ENGINEERING CHANGE NOTICE NO. 04948

DWG NO. 647.3900

DWG TITLE: DEFLECTORS

REASON: REVISED TOLERANCE AND NOTES

SHEET 5, ZONE C6 IS:

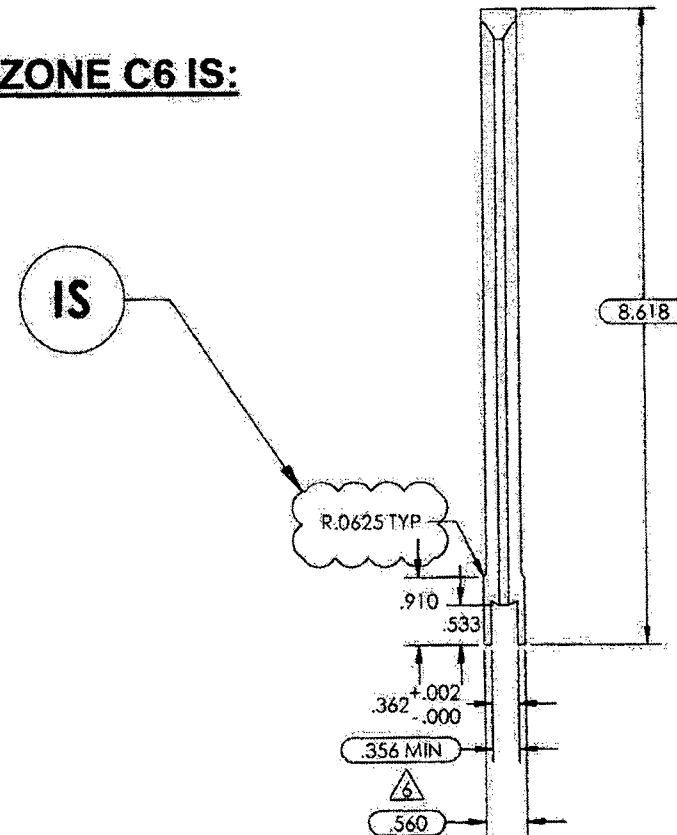
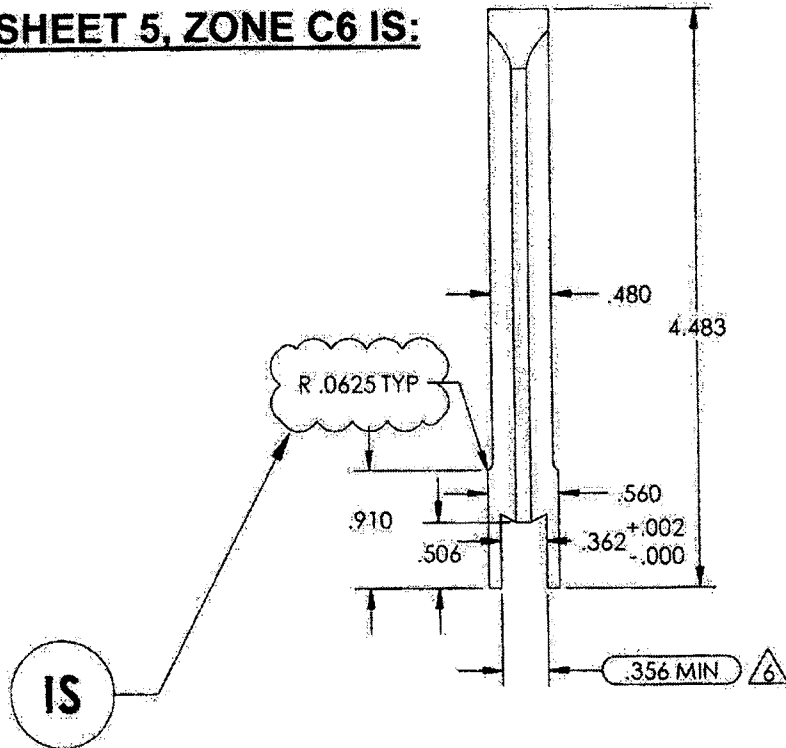
REASON: CHANGED P/N, DIMENSIONS & REVISED BOM
